To: Cheryl Low, Environmental Manager, Matakanui Gold Ltd
 From: Jens Rekker, Principal Hydrogeologist, Kōmanawa Solutions
 CC: Matt Dumont, Senior Computational Hydrologist, Kōmanawa Solutions
 Date: 11 September 2026
 Subject: BOGP FTAA Application Processing - RFI-11; Responses to RFI Responses by Other Parties

Kōmanawa Solutions has been asked for responses to responses received from parties to the Bendigo – Ophir Gold (BOGP) Fast-Track Approvals Act (FTAA) arising from the Panel’s Request for Further Information number 11 (RFI-11).

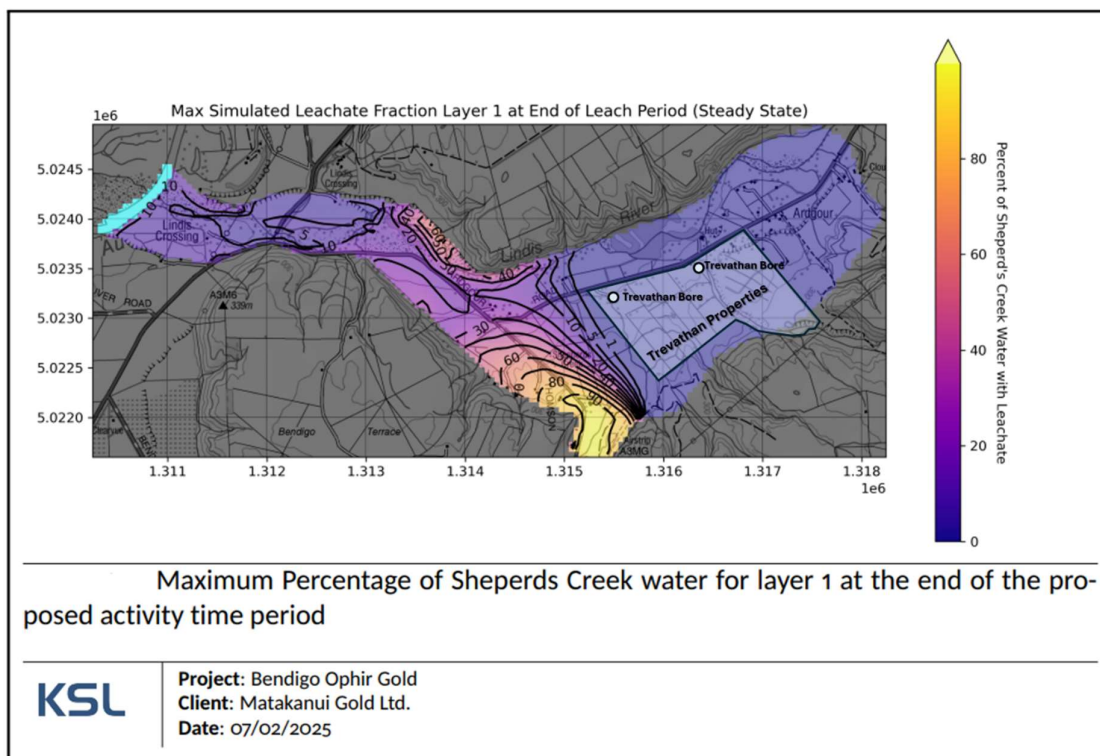
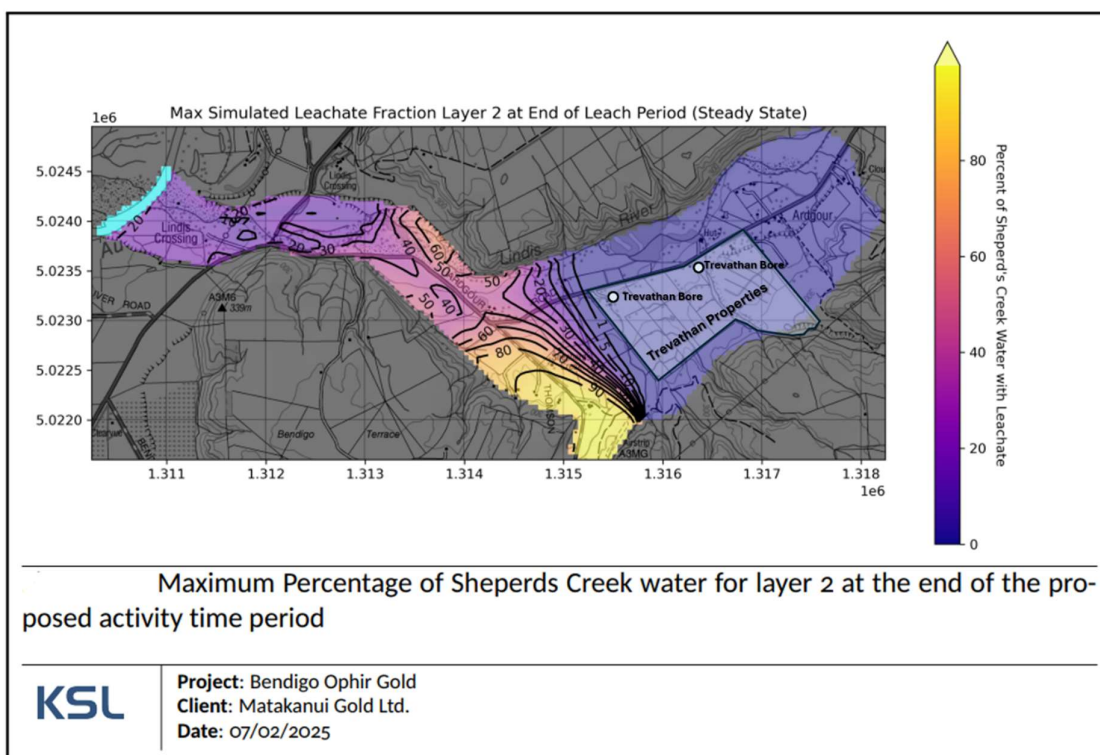
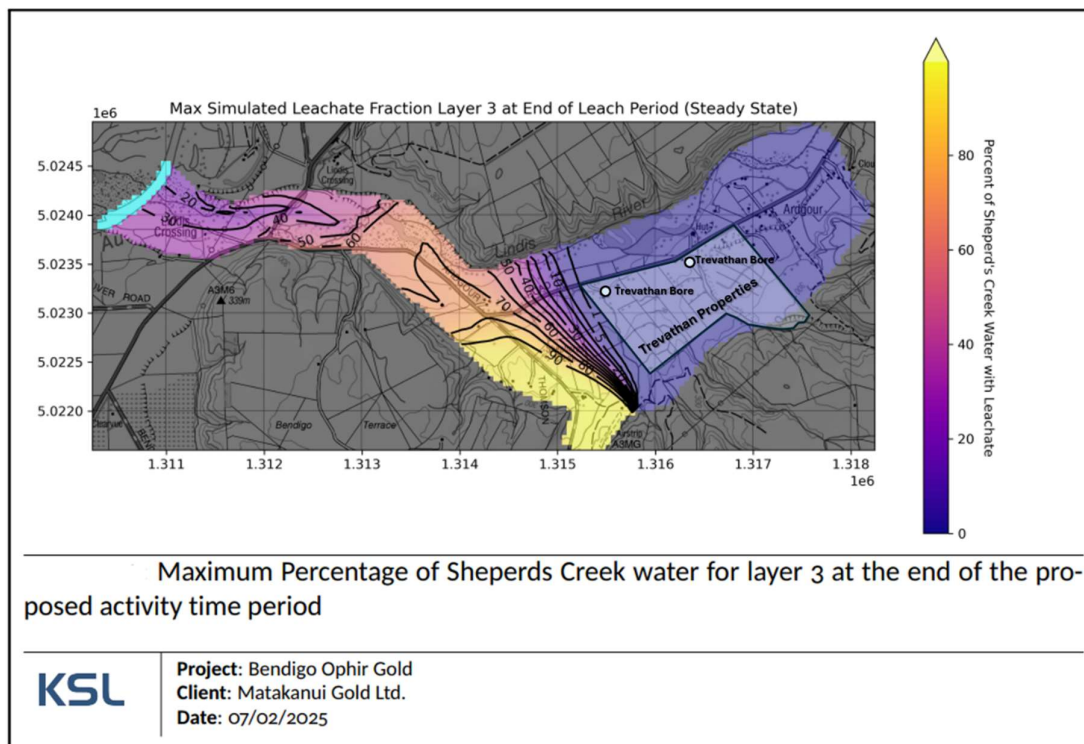
35. They also seek that additional ground water monitoring bores are installed along their boundary so that they can have confidence that the water traveling into the ground under their property and relied upon by them is good quality.

The Trevathan Family response requests that “additional ground water monitoring bores are installed along their boundary so that they can have confidence that the water traveling into the ground under their property and relied upon by them is good quality.” The Trevathan property is across the Ardgour Valley Aquifer (AVA) and parts of the Lindis Alluvial ribbon Aquifer (LARA) as mapped by ORC. These aquifers are composed of sandy gravel. On either side of the Ardgour Road the depth to the water table is shallow to moderately shallow, between 3 – 14 metres below ground. The gravels are highly permeable and porous, allowing creeks such as Shepherds and Dry Creek to pass underground, for other than flood conditions.

Kōmanawa Solutions has characterised the groundwater around the Trevathan Family properties in 2025 (Dumont & Rekker, 2025). Among the groundwater modelling simulations was the extent to which Shepherds Creek groundwater would penetrate the Ardgour Valley Aquifer and Lindis Alluvial Ribbon Aquifer on the way to seeping through the bed of the Lindis River, as plotted in Figure 2, Figure 3 and Figure 4.

The three groundwater model realisations covering all depths of the AVA and LARA each indicate that less than 1% of Shepherds Creek groundwater would cross the Trevathan Family property boundaries and towards the closest Trevathan bore, G41/0152. The mechanism for the low percentage groundwater origination from Shepherds Creek was attributed to the contributions of Lindis River, Dry Creek and Land Surface Recharge displacing Shepherds Creek derived groundwater downstream in the direction of Lindis Crossing. Therefore, the risk of Trevathan Family groundwater being materially affected by Shepherds Creek groundwater or surface water is low.

Thus, the string of surface water compliance at SC-01, groundwater compliance at GW-01, groundwater performance monitoring at GW-02 and GW-10 combined to provide adequate groundwater quality monitoring for the Ardgour Valley Aquifer. As the Trevathan Family properties' groundwater resources are demonstrably influenced by the water quality of the upstream Lindis River and Dry Creek, each unaffected by the Shepherds Creek catchment, the Trevathan Family's request for installation and surveillance of boundary groundwater monitoring bores is not justified.
